Memorandum for: Portland District, Operations Division, Regulatory Branch (LaDouceur)

Subject: Portland Sediment Evaluation Team (PSET) review of the July 19, 2013 revised *Preliminary Data Review Port of St. Helens* (SCR), and supplemental information submittals received from Northern Resources Consulting (NRC) up to September 25, 2013. The proposed dredging project is located in Scappoose Bay, near Columbia River Mile (RM) 88.5, St. Helens, Columbia County, Oregon.

FIGURE 1

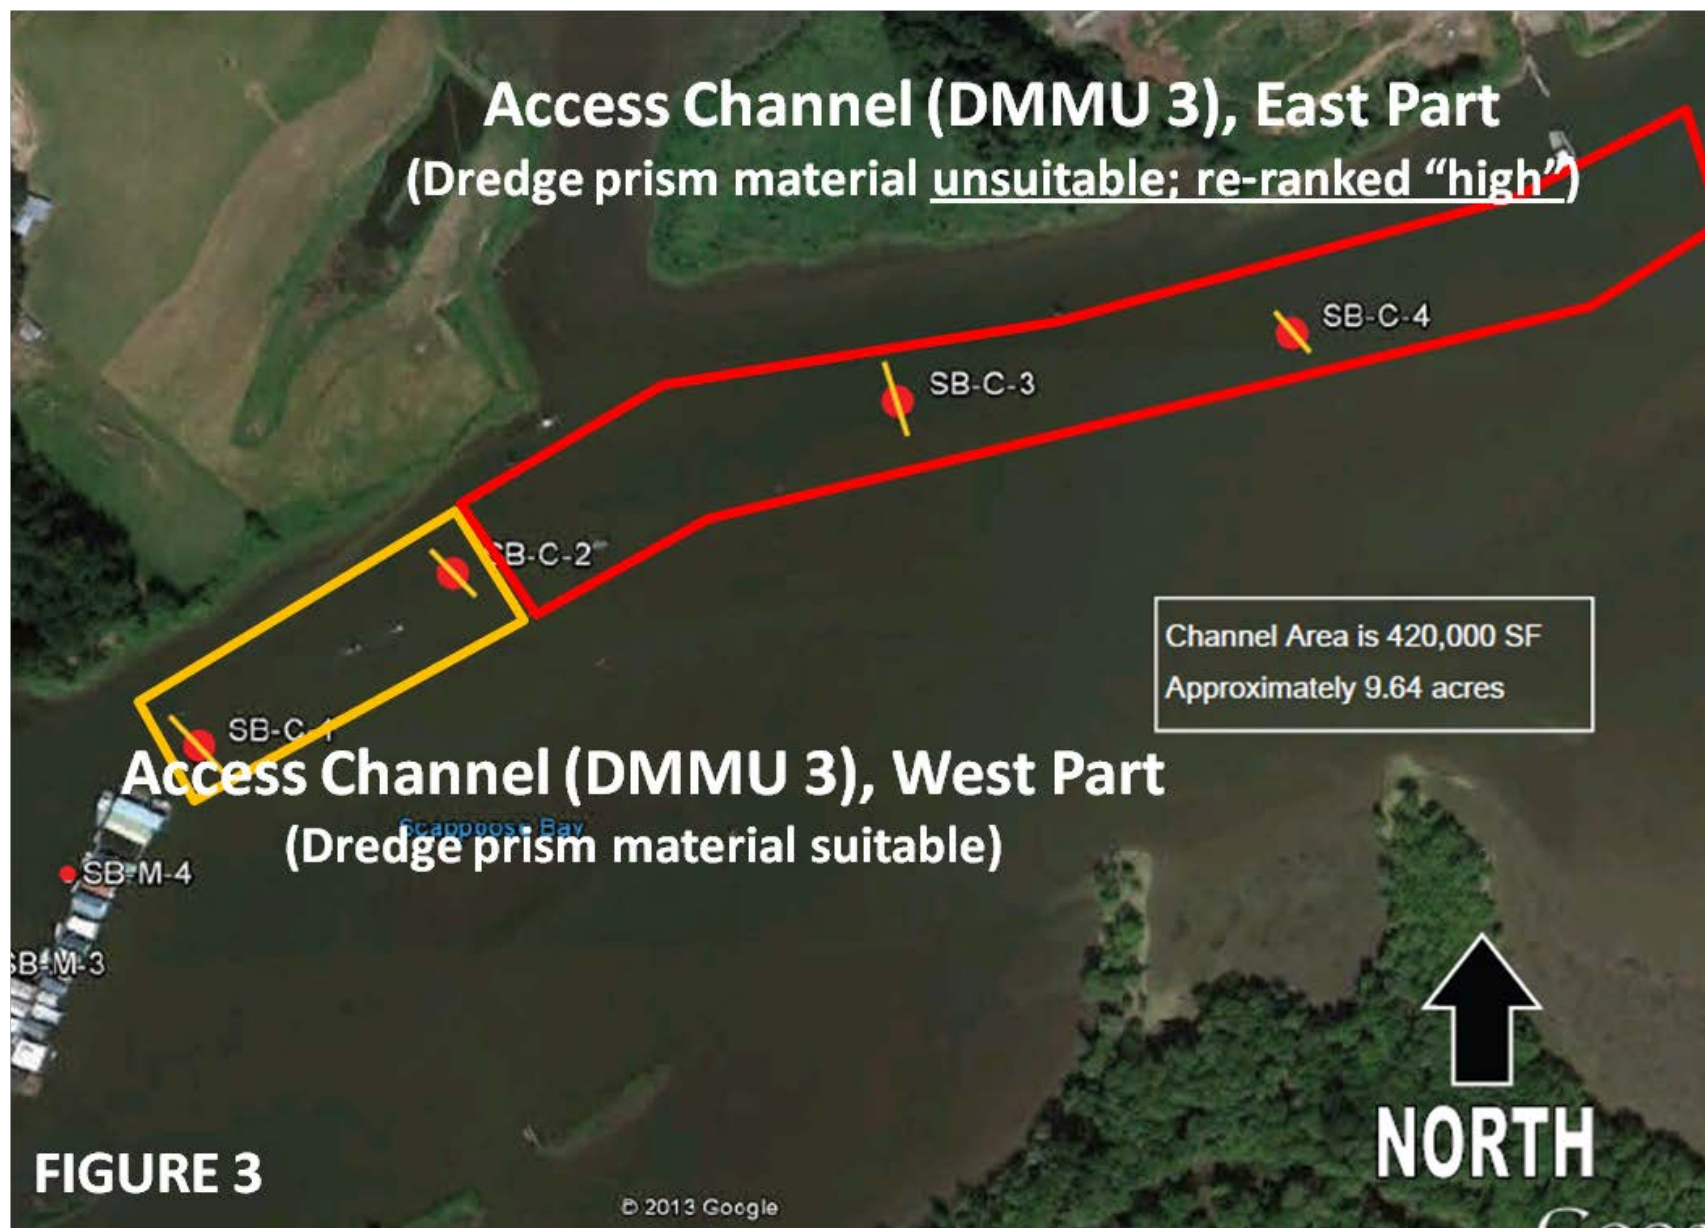
Marina: The marina was split into two equal-volume DMMUs (DMMUs 1 and 2; Figures 1 and 2). The planned dredge prism sample interval extends from the mudline to -7 feet NGVD29; the planned NSM sample interval in the marina extends from -7 to -9 feet NGVD29.

(Dredge prism and NSM suitable)

(Dredge prism and NSM suitable)

Dredge prism material from the marina and the west part of the access channel is suitable for unconfined, aquatic placement without additional characterization. **Due to contamination by arsenic, zinc, and PCBs, the dredge prism material in the east part of the marina access channel is unsuitable for unconfined, aquatic placement.** Material must be placed in an upland location, or positive biological testing results (bioassays and bioaccumulation studies) must occur prior to dredging to override the sediment chemistry review.

The NSM in the marina is suitable for unconfined, aquatic exposure without additional characterization and meets ODEQ's anti-degradation policy. **Due to arsenic contamination, the entire access channel NSM is unsuitable for unconfined, aquatic exposure.** The access channel NSM will require post-dredge monitoring and/or management by the Port. **It is the Port's responsibility to identify how they will manage contamination in the access channel NSM. Prior to dredging, the Port must provide a project-wide dredging plan to the PSET which includes options to manage contamination in the access channel NSM.** Alternatively, biological testing of contaminated sediments with positive results (bioassays and bioaccumulation studies) must occur prior to dredging to override the sediment chemistry review.

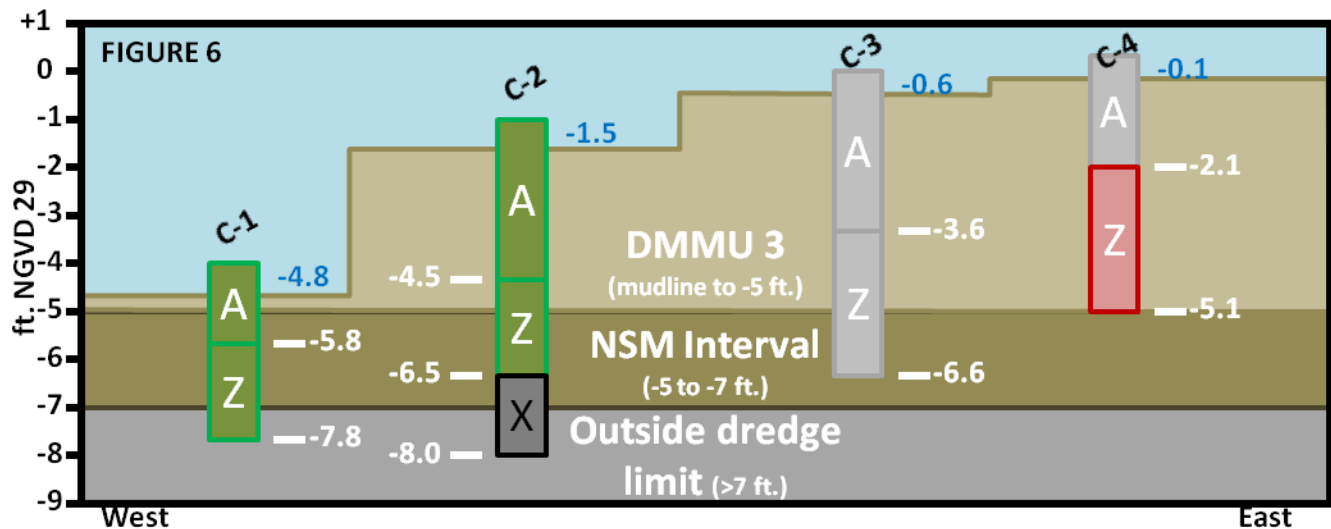
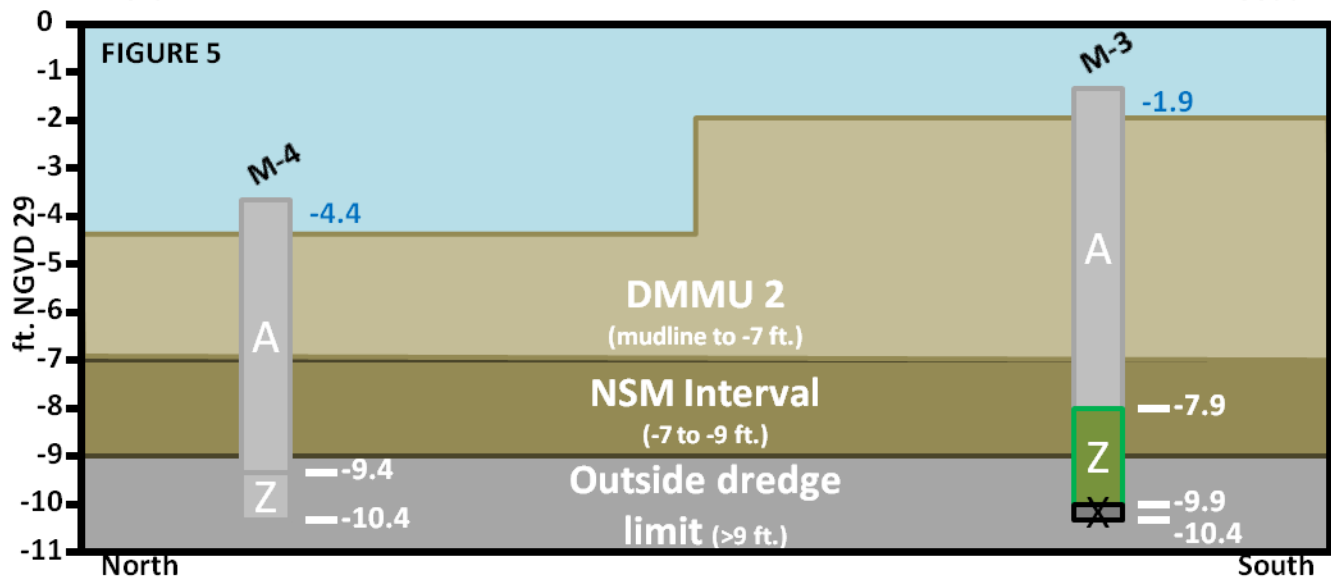
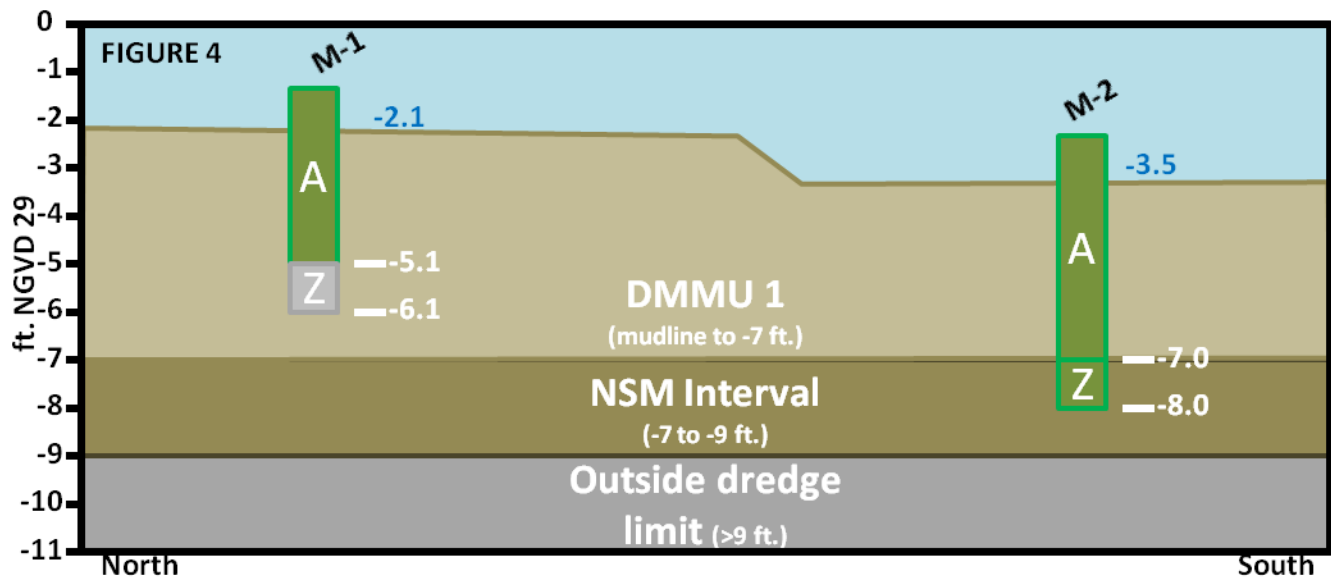
- Only one dredge prism subsample (SB-M-2-A), of four dredge prism subsamples captured the complete interval of sediment proposed in the SAP (Table 1; Figures 4 and 5).
- Three of the 4 NSM subsamples were 1 foot thick (a 2-foot thick sample was proposed in the SAP), and none of the NSM subsamples included the complete interval of material from -7 to -9 feet NGVD29.
- In one instance (core SB-M-1), the core barrel never penetrated into the NSM interval; the NSM sample from this core was composed entirely of dredge prism material.

- Dredge prism and NSM subsamples were not collected from the intervals proposed in the SAP (Table 1, Figure 6).
- NSM subsamples were either 2 or 3 feet thick, none of the NSM subsamples included the complete interval of material from -5 to -7 feet NGVD29, and each NSM subsample also contained material from the dredge prism or below the NSM interval.
- NSM subsample SB-C-3Z was composed of nearly equal parts dredge prism material and NSM material.
- Core SB-C-4 only penetrated 0.1 foot into the NSM; subsample SB-C-4Z was mostly composed of dredge prism material.
